Re: EQ#24-2665 Seventh Day Adventist Subdivision Review  
EQ#24-2506 Seventh Day Adventist Public Wastewater Review  
EQ#24-2444 Seventh Day Adventist Public Water System Review

This letter is in response to your review letter for the subdivision, public wastewater, and public water review. Below you will find individual responses to each of your presented deficiencies. Attached you can find supporting materials with the requested updates.

**GENERAL**  
COS  
SITE LAYOUT

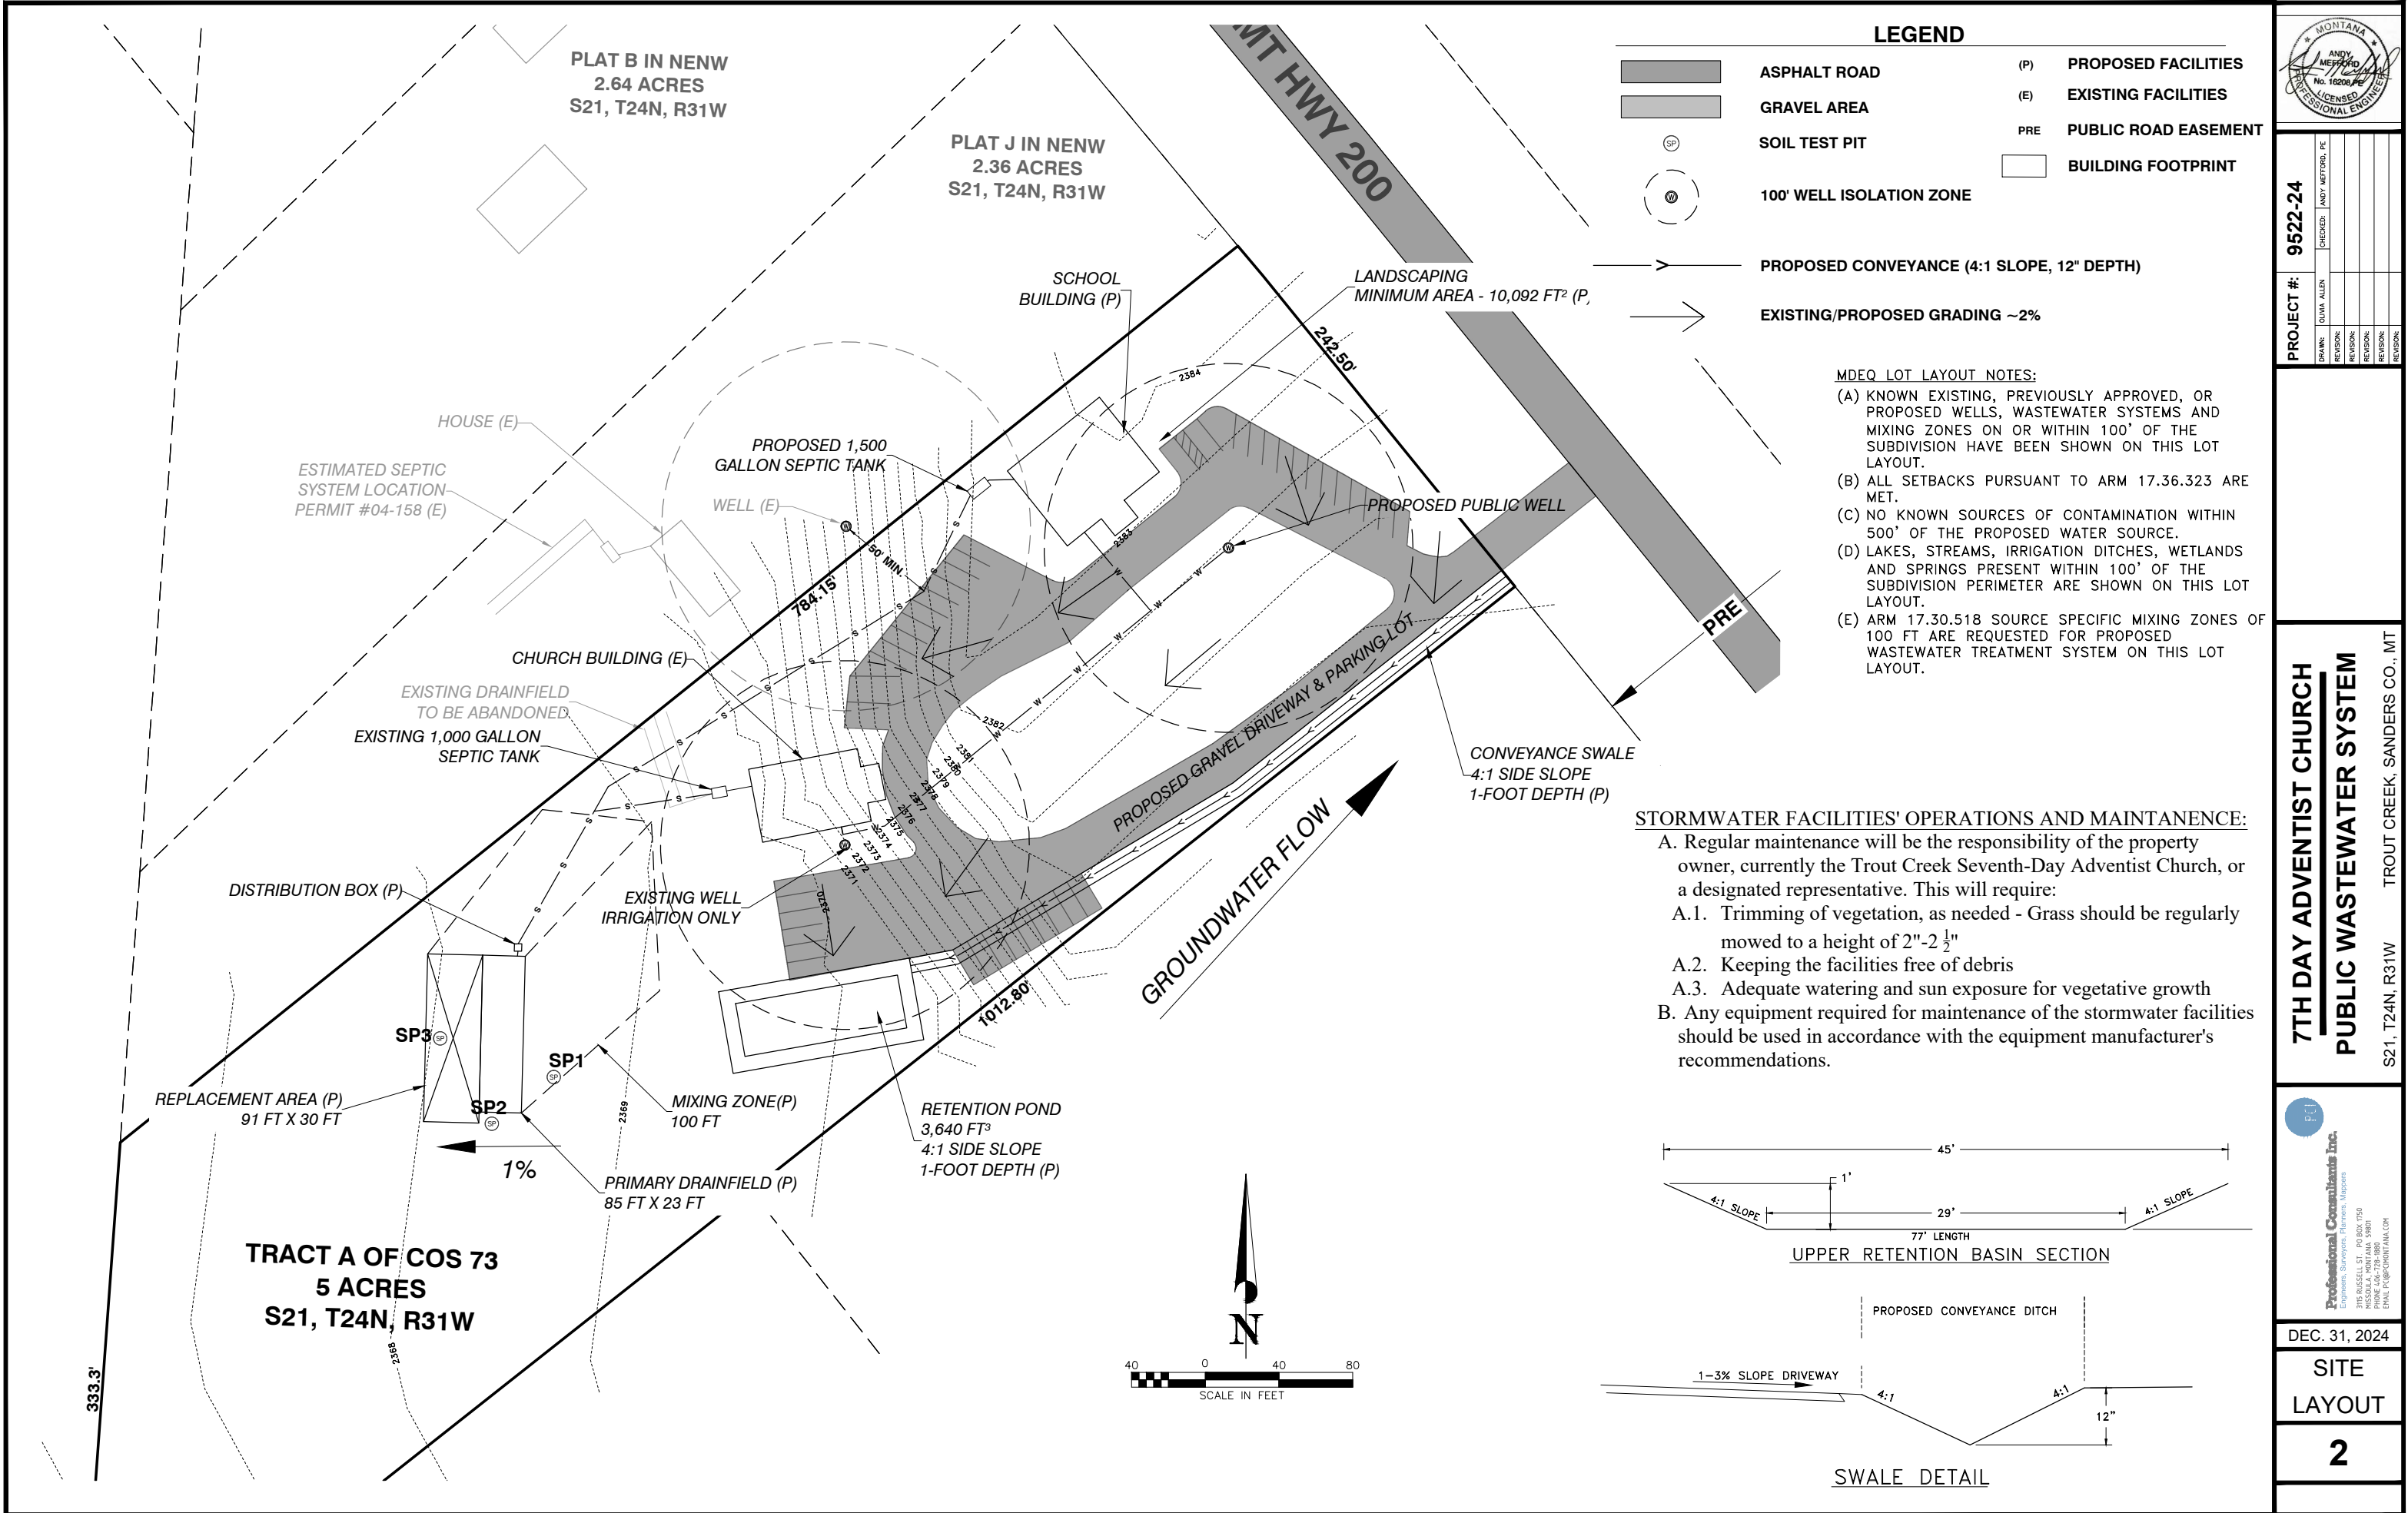
2. Consider changing Note (c) on site layout that says, "no known sources of contamination within 500' of the proposed water source." The proposed drainfield is currently shown 200' upgradient of the proposed public well.

- *Note has been changed stating all known sources are shown.*
3. Please show the following on the Lot Layout, ARM 17.36.104 Table 1
  - a) Percent and direction of slope across the drainfield.

- b) Location sizes and design details of existing and proposed stormwater facilities.
  - *See updates on attached layout.*
4. ARM 17.36.323, Table 2, Setbacks. The sewer service does not meet the 100' setback to public drainfield see footnote (1), "components addressed in chapters 4 and 5 in Department Circular DEQ-4," and therefore a waiver to setbacks is required. Will Sanders County require a variance? If so, this must be submitted before a waiver to these facilities is considered. This waiver is in addition to the DEQ-3, deviation requests. We will waive the waiver fee. Please remove note B on the lot layout as all setbacks in ARM 17.36.323 are not met.

6. Please indicate the direction of surface runoff flow across the property with either topography or stormwater runoff arrows. DEQ-8, Standard 2.2.C.1. As currently shown, I cannot determine if the stormwater swale will retain the stormwater runoff.

- *The adjusted drainfield location and proposed public well location no longer require these waivers.*

- *See attached Site Layout 2 that shows specific stormwater details.*

- *There is no longer landscaping proposed. The existing and proposed impervious areas are graded toward the conveyance swale that will direct stormwater to a single retention pond. See updated report, calculation sheets, and details.*

**CERTIFICATE OF SURVEY NO. 73**  
**NW<sup>4</sup>, SECTION 21, T.24N., R.31W., M.P.M.**  
**COUNTY OF SANDERS, MONTANA**

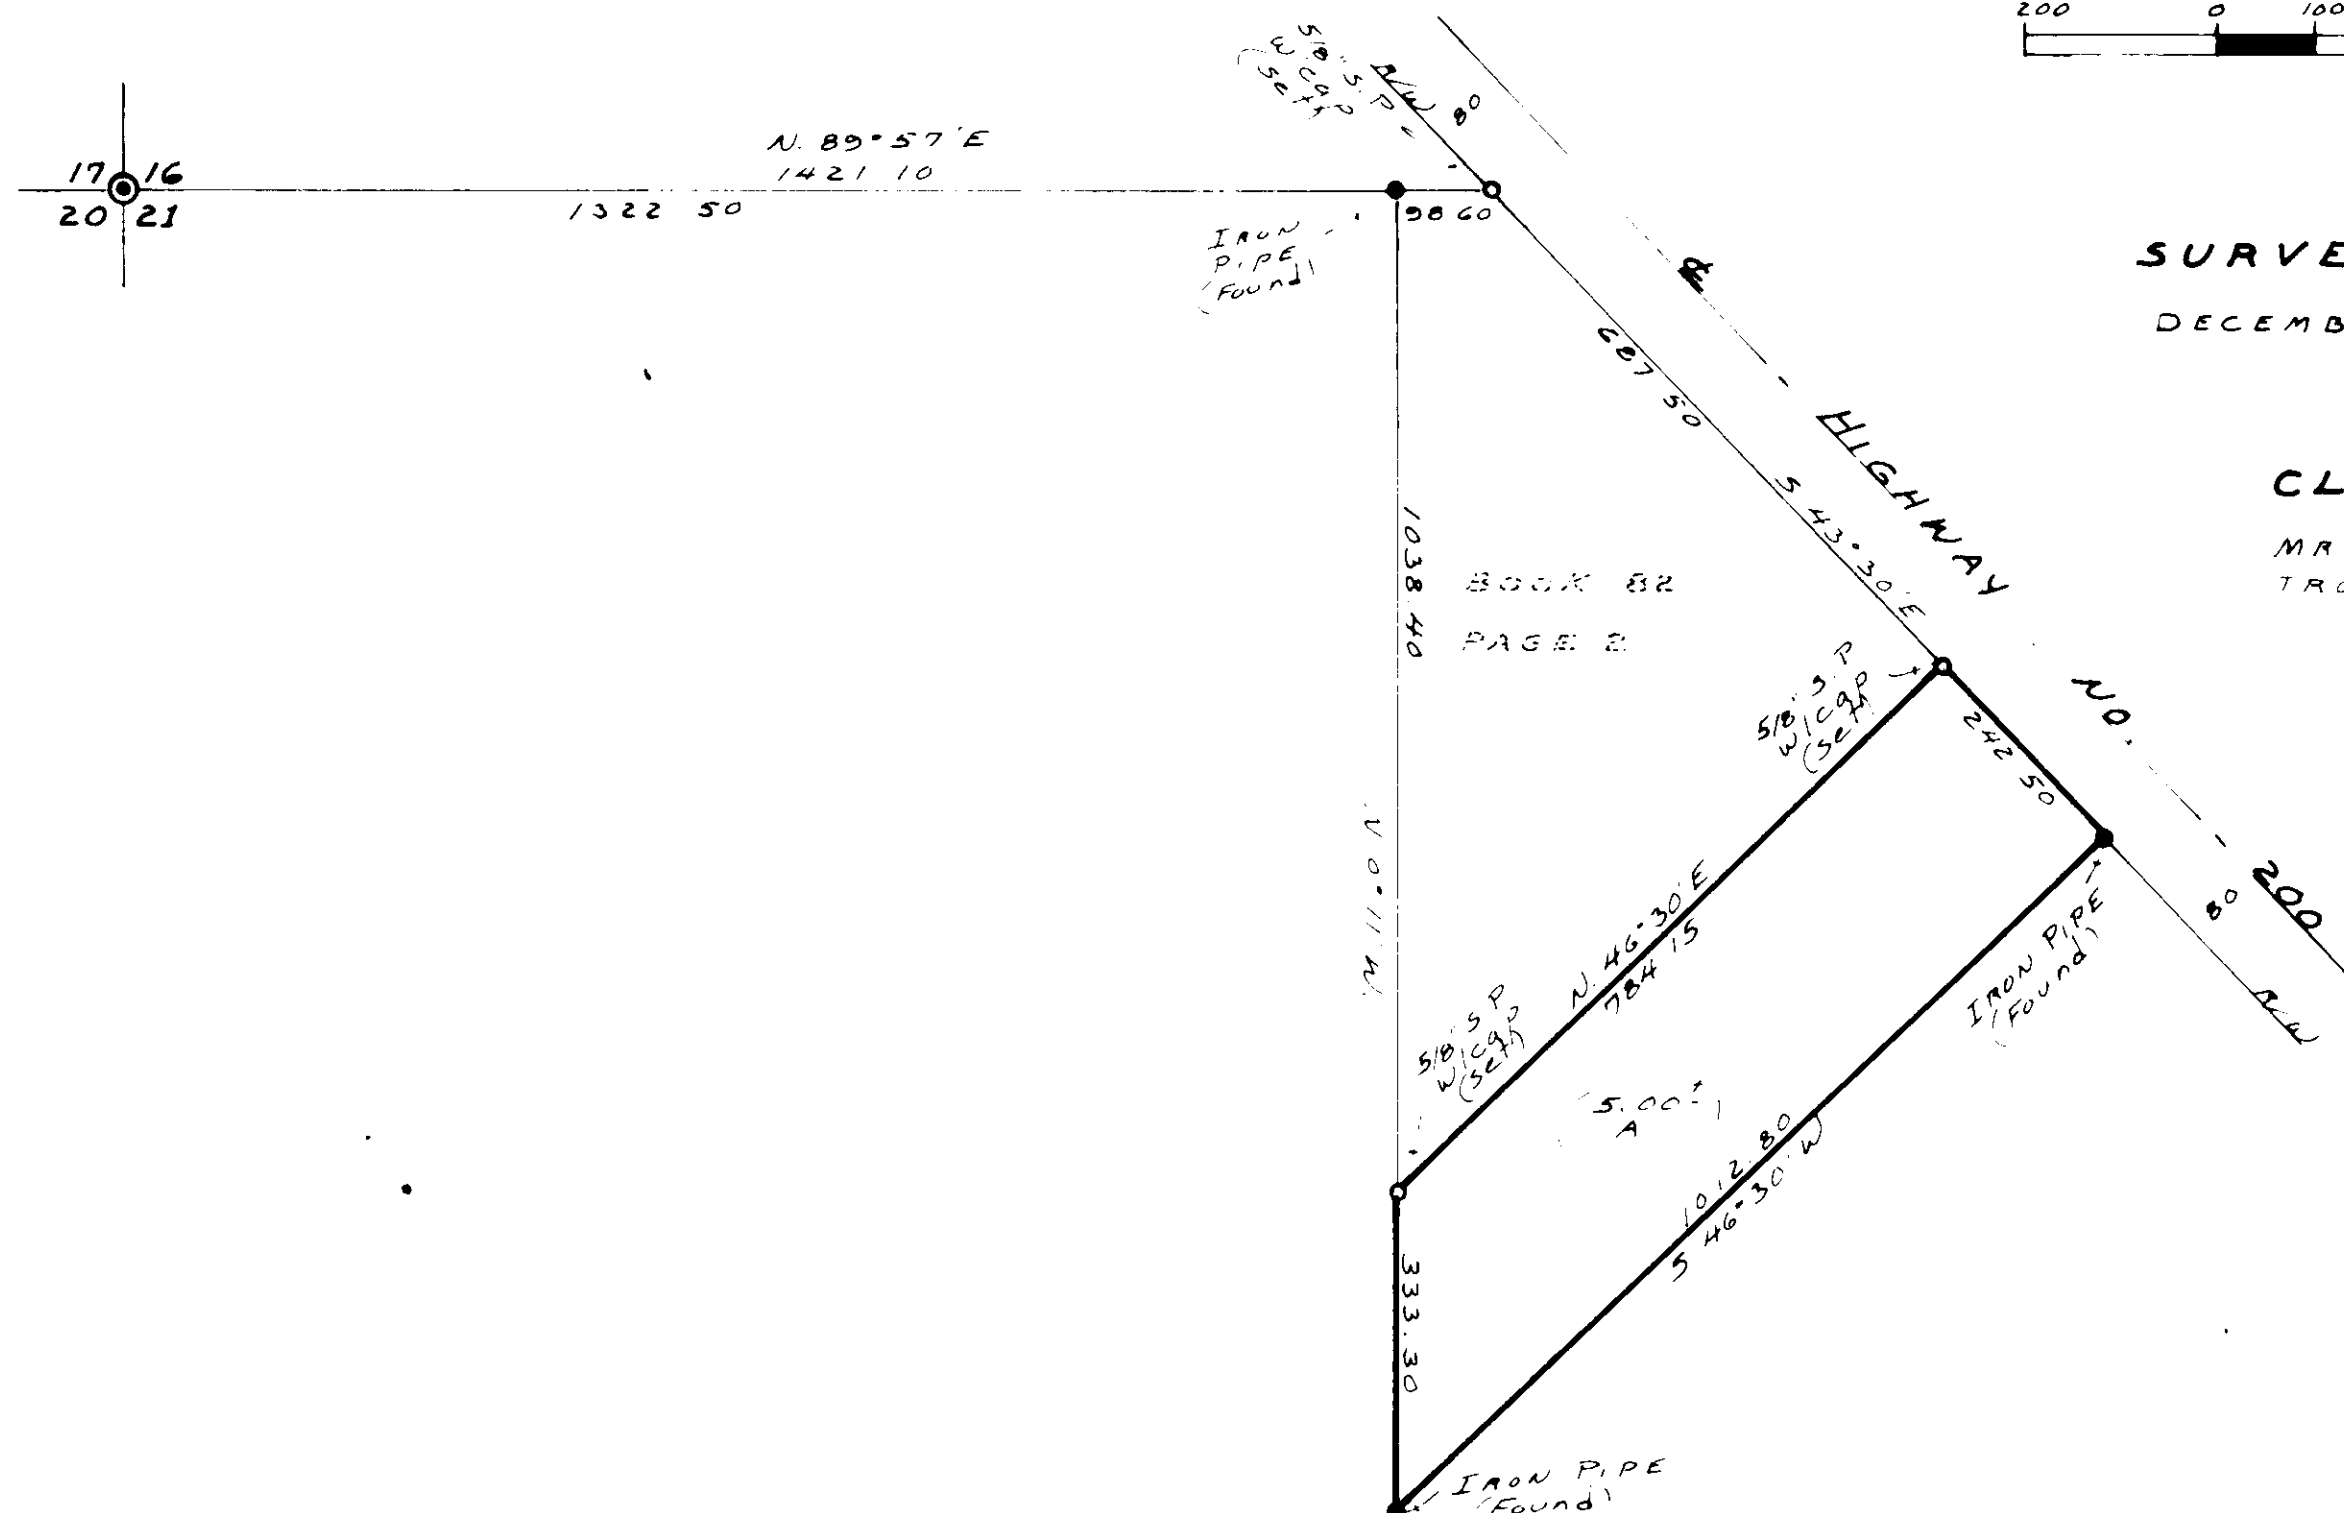
1. Please provide a legible copy of the COS with the date clearly shown, ARM 17.36.103(1).
  - *The attached COS shows the survey date as December 1974 and the purpose is to create a five-acre tract as an "occasional sale."*

DISTRIBUTION BOX DETAIL  
NOT TO SCALE

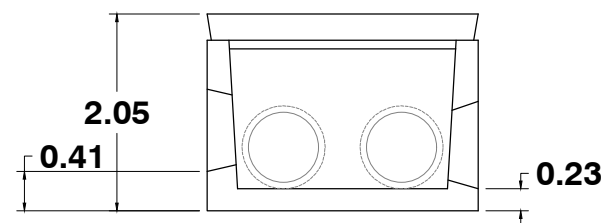
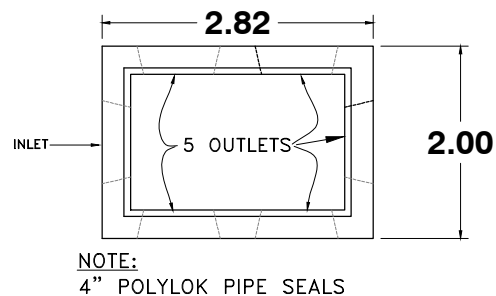
10. Please add notes to the distribution box detail to meet the requirements of DEQ-4, Standard 4.3.3.1.

- *Note has been added.*

SEPTIC  
DETAILS

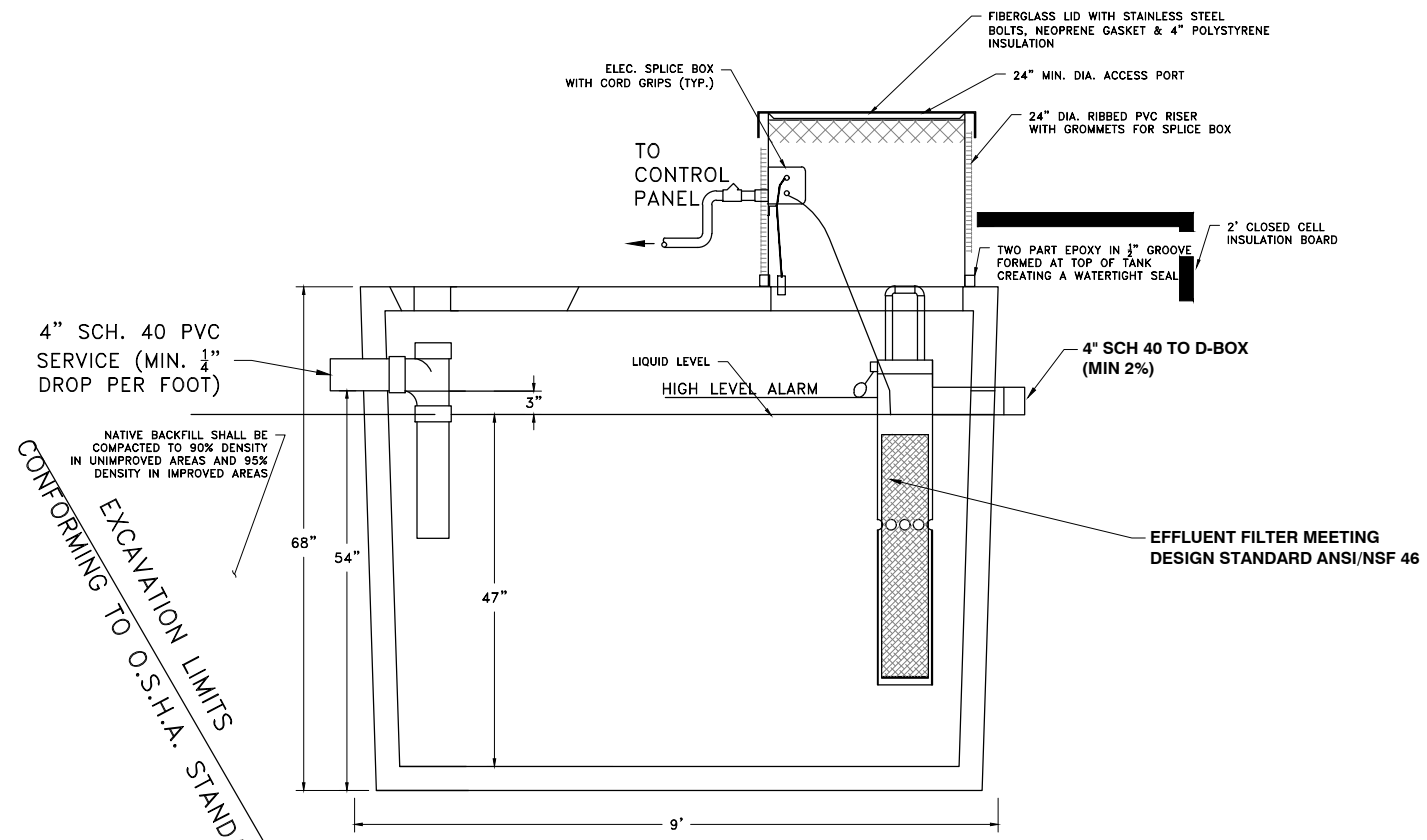
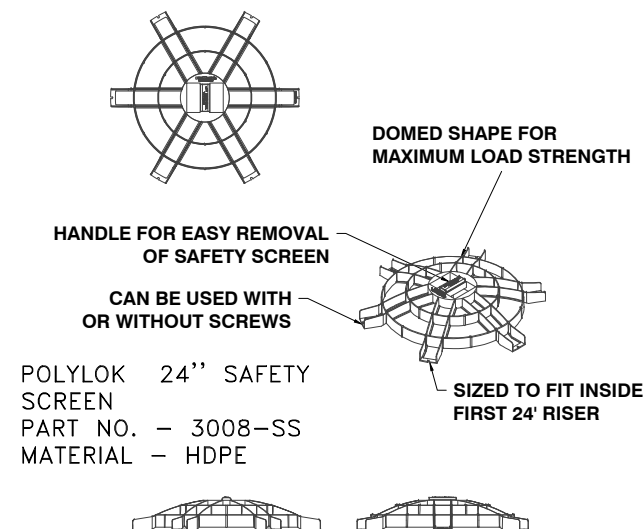
8. DEQ-4, Standard 4.1.1.7 requires Schedule 40 PVC sewer pipe leading into and out of the septic tank.

9. Please add a note to the plans showing the sewer service connection must be placed at a minimum slope of ¼ inch per foot toward the point of discharge, DEQ-4, Standard 4.1.2.1.

- *See updated details that show the proposed and existing septic tanks. The existing tank was installed in 2023 and is a pre-cast concrete tank from Montana Precast.*

- *The notes have been added for both septic tanks. The existing tank already meets this requirement.*

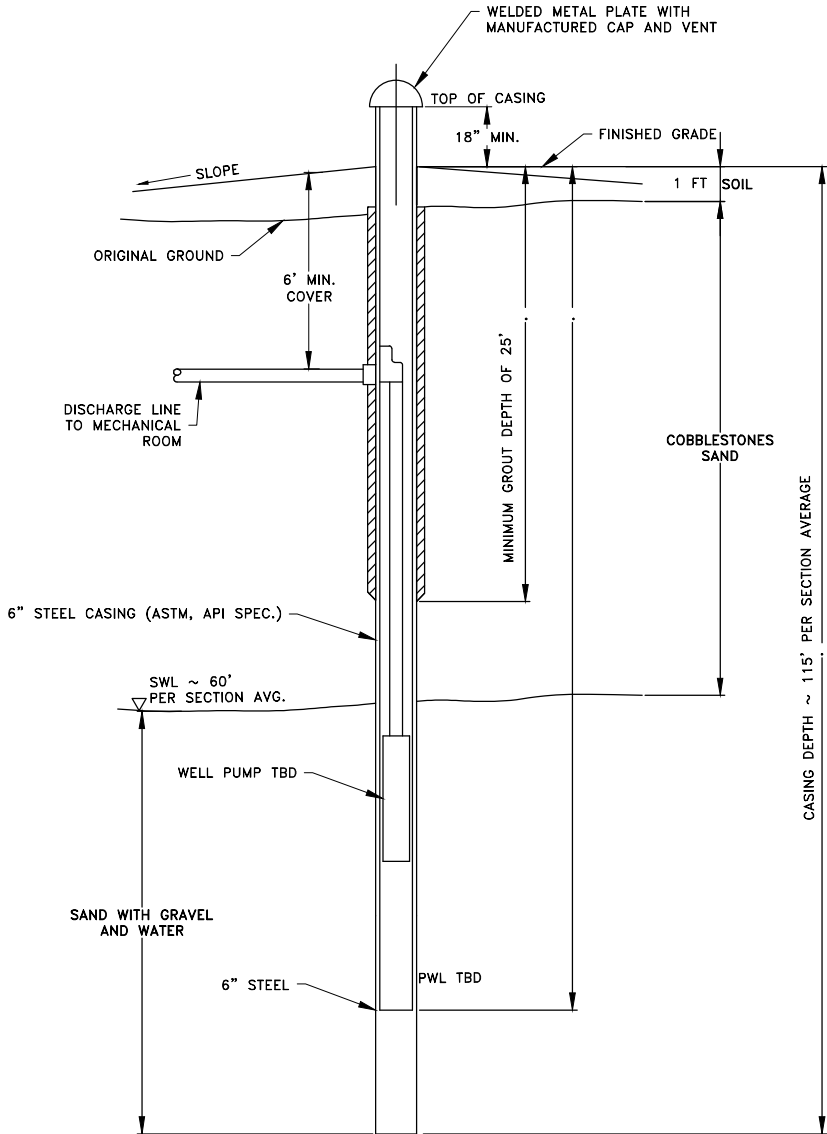
6. Please show the elevations and designations of geologic formations on the typical well profile, DEQ-3, Standard 1.2.2.b

- *The well profile has been updated to show what is expected of the new well.*
